CASE INFORMATION

CASE:	UDP-S24025
MEETING DATE:	April 23, 2024
REQUEST:	Site Plan Level II Review: 290-Unit Multifamily Residential Development and 3,070 Square Feet of Retail Use with an Associated Parking Reduction in the Downtown Regional Activity Center
APPLICANT:	501 Urban Warehouse, LLC.
AGENT:	Stephanie Toothaker, Esq.
PROJECT NAME:	500 Arts Lofts
PROPERTY ADDRESS:	500 SW 2nd Avenue
ZONING DISTRICT:	Regional Activity Center - Southwest Mixed Use District (RAC-SMU)
LAND USE:	Downtown Regional Activity Center
COMMISSION DISTRICT:	4 - Warren Sturman
NEIGHBORHOOD ASSOCIATION:	Tarpon River Civic Association
CASE PLANNER:	Lorraine Tappen

Case Number: UDP-S24025

TOD Guidelines

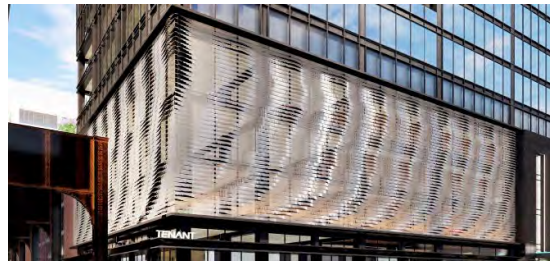
- k. **T5,** Additional details concerning the method of screening the parking garage is needed. Elevations do not indicate type of material to be used or method of how vehicle headlights will be screened.
- l. **T5,** Include parking for mopeds, scooters, motorcycles, and other similar vehicles.

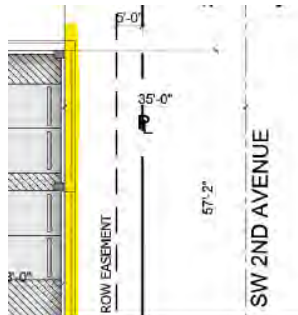
13. As designed and oriented, the building does not support allowing light and air at the street level. Also, the multistory parking podium is out of scale with the building and the narrow width of the SW 5th Street right-of-way. Discuss in narrative methods for adjusting the design to meeting Downtown Master Plan guidelines regarding building design.

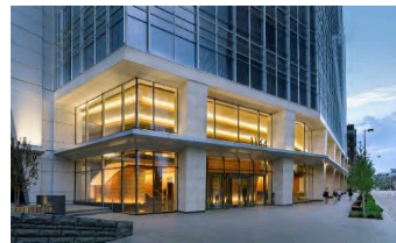
- k. T5, Additional details concerning the method of screening the parking garage is needed. Elevations do not indicate type of material to be used or method of how vehicle headlights will be screened.

UDP Response: Can you show that the lights of an SUV would be blocked by the crash wall?

REV 1 Response: Concrete crash walls are provided to screen the car headlights. Refer to the detailed sections on sheets A313 and A314. Mesh screens with decorative aluminum frames are used to screen the façade openings.

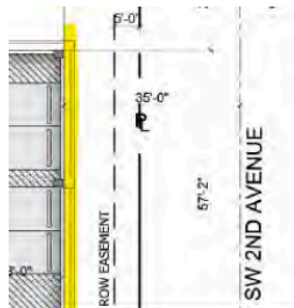
13. As designed and oriented, the building does not support allowing light and air at the street level. Also, the multistory parking podium is out of scale with the building and the narrow width of the SW 5th Street right-of-way. Discuss in narrative methods for adjusting the design to meeting Downtown Master Plan guidelines regarding building design.

REV 1 Response: The proposed design is a response to the configuration of the L-shaped property. A shadow study shows the design would provide more light and air to the streets than a design that would meet the Downtown Master Plan Design Guidelines which would require a longer and taller building for the same total Gross Floor Area

UDP Response: Acknowledged
